FCO 512-00182A

Improving the single-loading cassette's plate/paper separation

Document number: 719-00393A Rev A

- Lotem® 800
- Lotem 800 II
- Lotem 800 Quantum
- Lotem Quantum Spectrum

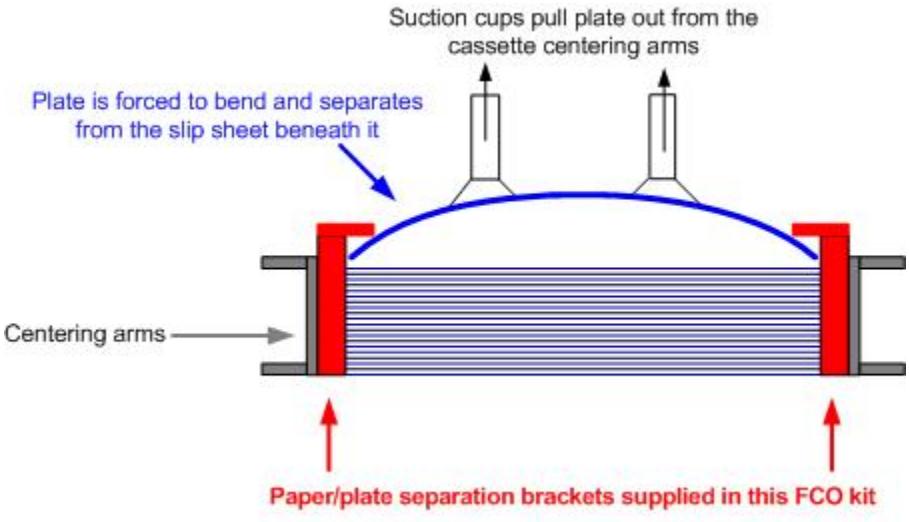
Problem

- Static electricity and/or a slip sheet that sticks to a plate may cause double feeding; meaning the plate and the slip sheet (immediately beneath the plate) are loaded together.
- During the plate loading process, the slip sheet does not separate from the plate that is immediately beneath it.

Install the improved SLC centering arms with the paper/plate separation brackets, supplied in this FCO kit. When *Step A* of the loading process is performed - *Loading plate from cassette entry to punch entry*, the improved centering arms and brackets cause the plate to bend in a convex shape. The convex bending forcibly separates the plate from any slip sheets that are immediately above and beneath the plate:

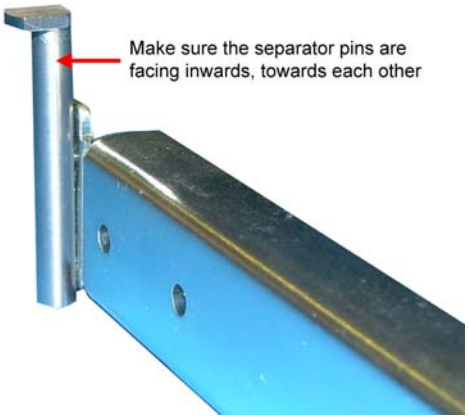
1. In Lotem Controller, remove the cassette.
2. Open the SLC's cassette cover.
3. Remove all the plates from the cassette.
4. Remove the two existing centering arms and put the screws to one side:

5. Use the screws from the previous centering arms to install the two improved centering arms (part number 293A9B140A). Make sure that the arms' separator pins are facing inwards, towards each other:
